AGENDA

Architectural Review Board

June 23, 2015

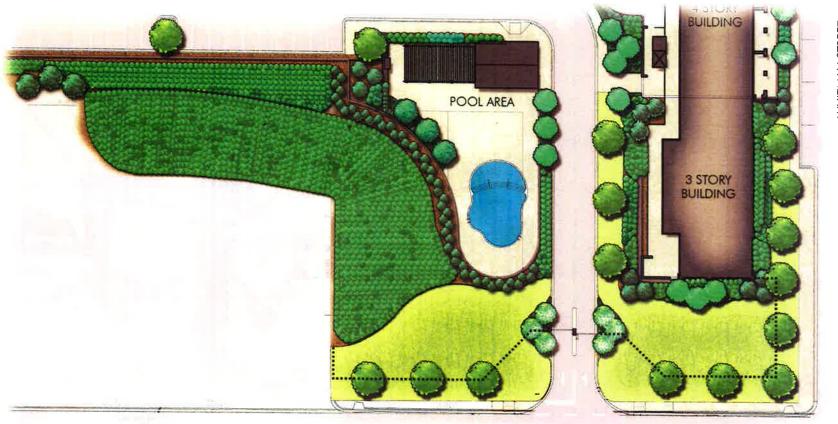
- Sign guidelines cite as acceptable: Proposed signs should not exceed 20 square feet of surface area. Designs for the mounting, framing, etc. must be approved. The material for the mounting should be compatible with the materials in the building. Style and color of lettering must be compatible with the building and location. Location of sign on lot must be approved. Lighting: top or ground lighting such as floods or spots."
- This project is entirely new construction.
- The Board has approved larger signs in cases where the scale of the building could accommodate a larger sign. The proposed sign exceeds the 20 SF recommendation.
- Proposed spots are appropriate under the guidelines.

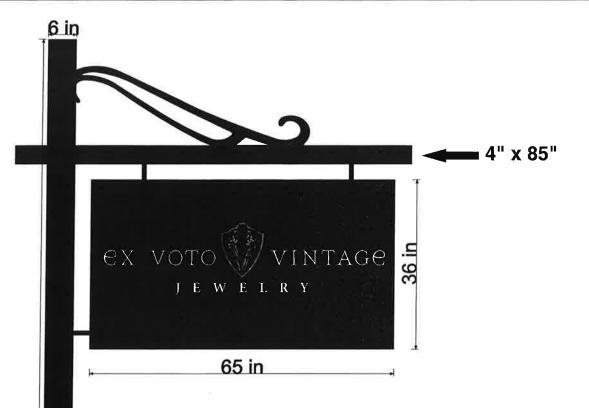
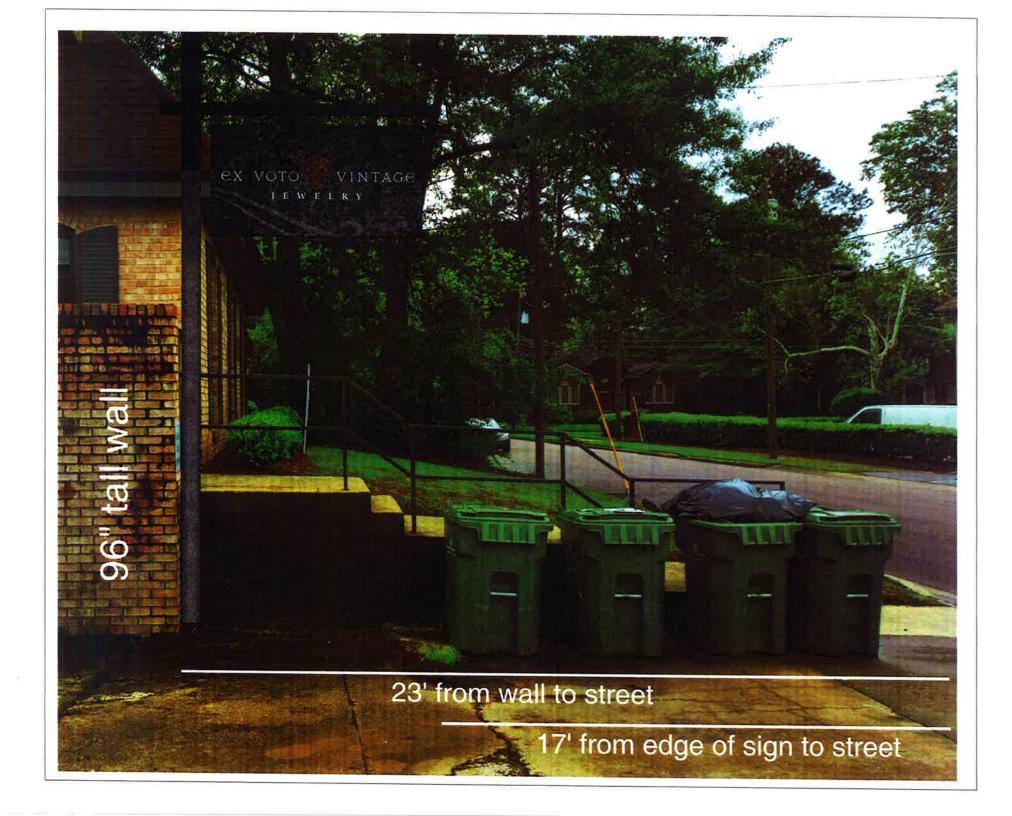
- Sign guidelines cite as acceptable: Proposed signs should not exceed 20 square feet of surface area. Designs for the mounting, framing, etc. must be approved. The material for the mounting should be compatible with the materials in the building. Style and color of lettering must be compatible with the building and location. Location of sign on lot must be approved. Lighting: top or ground lighting such as floods or spots.
- Signs as proposed meet the guidelines.

View of front side of proposed rear porch/patio cover

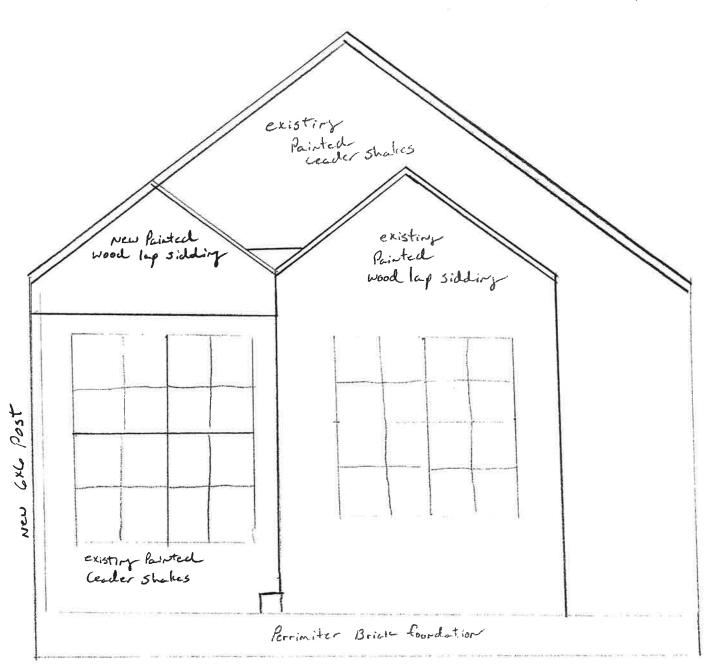
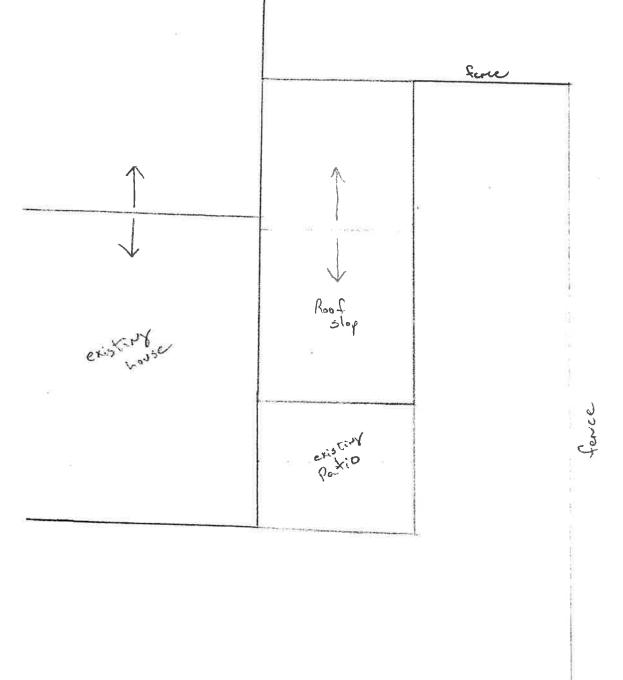
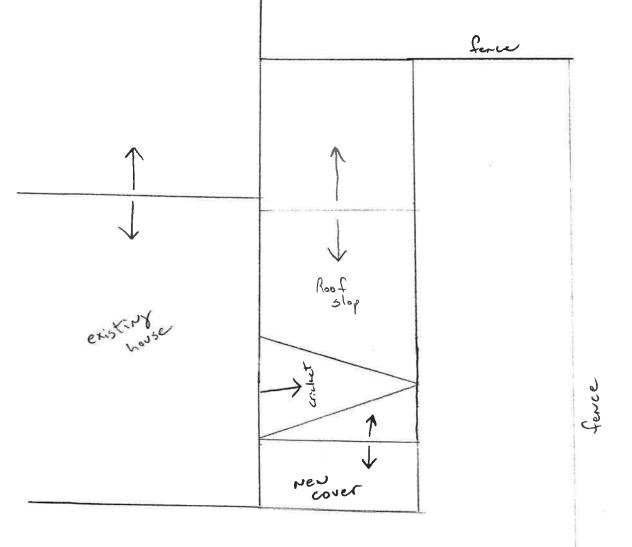
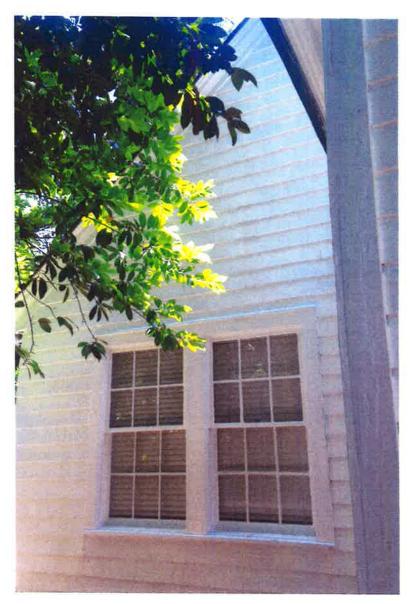
• The house is on a fairly small corner lot, the proposed parking is from the side street. A planted berm provides a vegetative screen of this parking area from the front and corner view of the house.

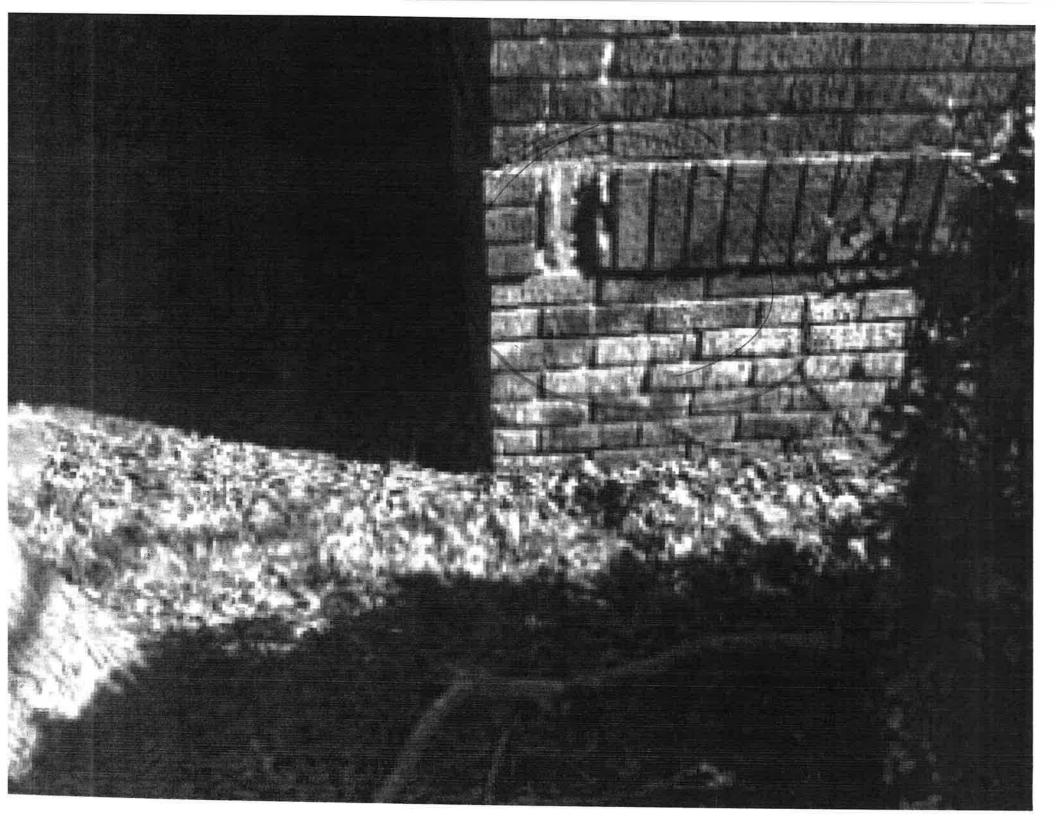
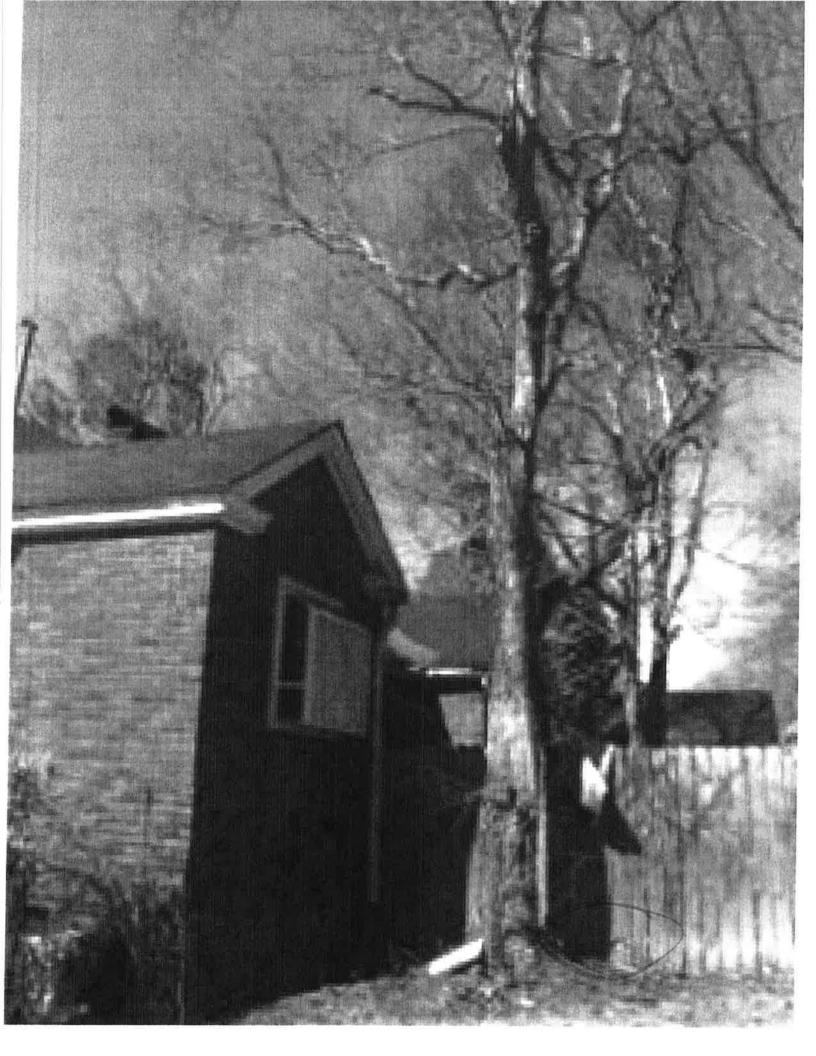
• Urban Forester recommends replacement.
